Review 1

**Shree Lakshmi Vardayini Urban Renewal, LLC**  
General Development Plan Amendment

Application P-24-003  
Harbor Station South Redevelopment Area (HS-2 District)  
Block 751, Lots 1.06, 1.07, 1.08, 1.09, 1.10, 1.12, 1.14, & 1.16

Figure 4. Proposed GDP Ground Floor Plan

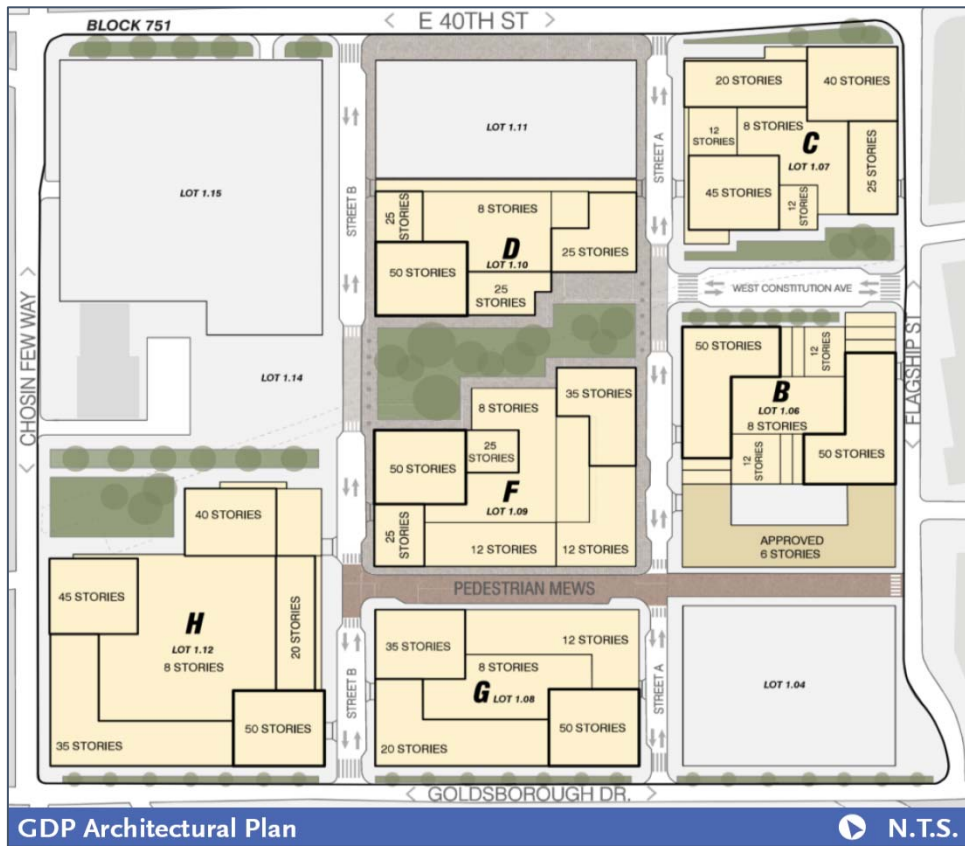
- 3.3. **Proposed Ground Floor Plan.** The proposed Ground Floor Plan is shown in Figure 4. The plan proposes parking garages on each block to be wrapped at the ground level with retail spaces and lobbies for residential and hotel buildings. A retail space with dimensions of 10 feet by 90 feet is proposed on the northeast side of Parcel H. **Testimony should be provided regarding the proposed ground floor retail space dimensions of Parcel H and other buildings and how the proposed configurations will function for prospective commercial tenants.**

Figure 5. Proposed Alignment of West Constitution Ave

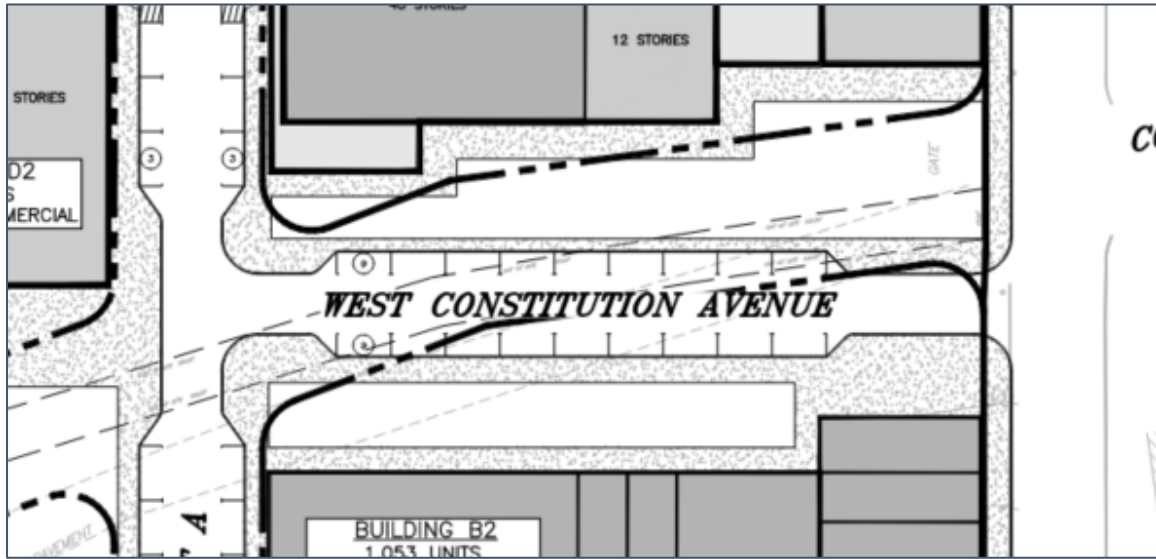
- 3.4. **Proposed Street Realignment.** The applicant proposes to realign the previously approved street grid on Lot 1.16. The approved street and lot lines followed the path of the sewer easement on Lot 1.16, whereas the proposed street is perpendicular to Flagship Street and overlaps Lot 1.06. Rectilinear pocket parks are proposed on both sides of West Constitution Avenue. Lot lines and rights-of-way will need to be reconfigured by subdivision to reflect the proposed layout of streets and open space when the first phase is proposed.

Figure 7. 3D Massing Diagram

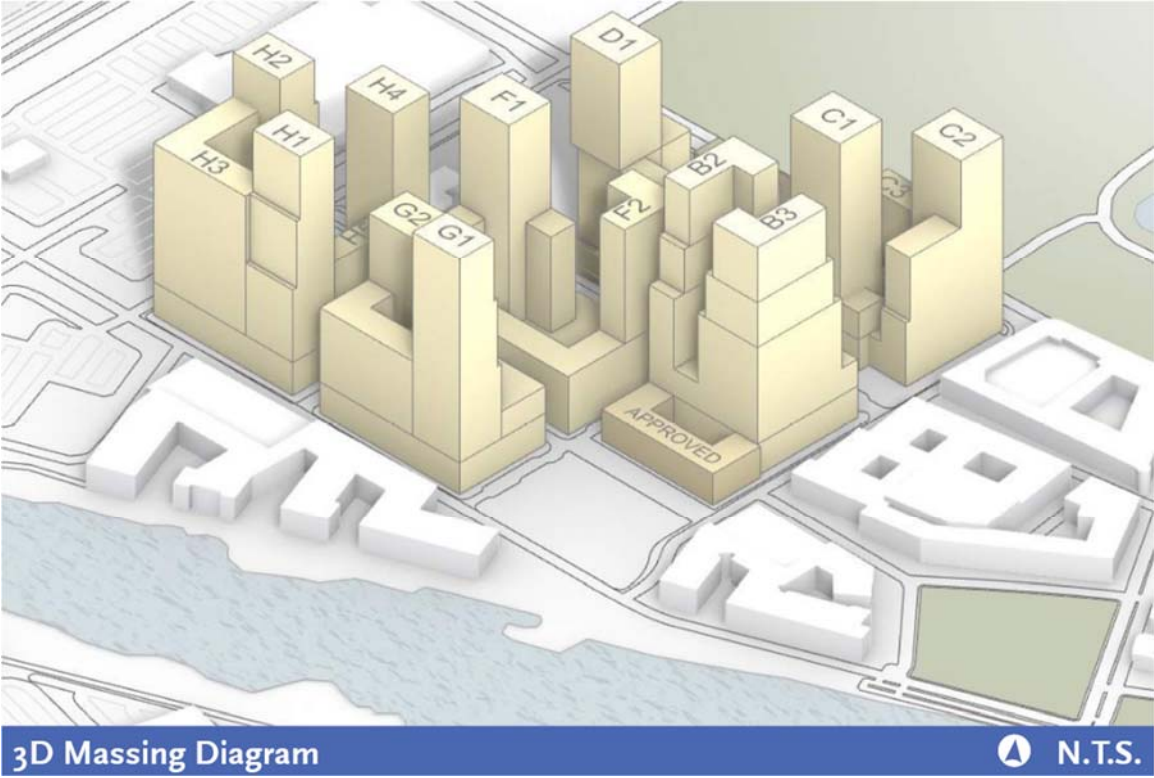
4.2.2. **Proposed Massing.** Proposed building massing is shown in the 3D diagram in Figure 7. The GDP amendment proposes high rise development on each block, including buildings that front existing or approved six-story buildings located on- and off-site. The massing of the buildings does not appear to relate contextually to the surrounding blocks within the Redevelopment Area. The proposed 50-story buildings front existing or approved 6-story buildings. **Step-backs should be provided on blocks within the amended GDP area where proposed high-rise buildings front lower-density buildings to provide a visually cohesive architectural design throughout the Redevelopment Area. Perspective renderings of the streets that bound the GDP area (Goldsborough Drive, Chosin Few Way, and Flagship Street) are recommended to demonstrate the visual relationship between the proposed buildings and existing neighboring development.**
